## Team Update 07

*Figure 7-3: Don't touch opponents' ROPES in the final thirty (30) seconds of the MATCH.*

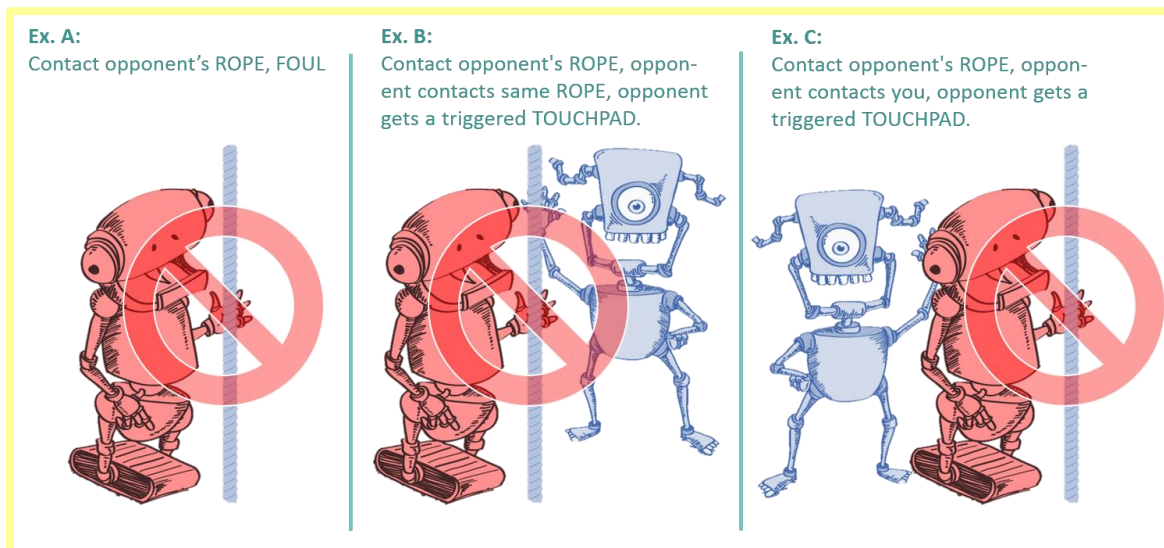
- G20. Let 'em climb: don't touch their ROPES.** During the final thirty (30) seconds of a MATCH, ROBOTS may not contact an opposing ALLIANCE'S ROPE.

Violation: FOUL. If an opposing ROBOT contacts the offending ROBOT or the ROPE, the opposing ROBOT is considered to have triggered an un-triggered TOUCHPAD at the end of the MATCH.
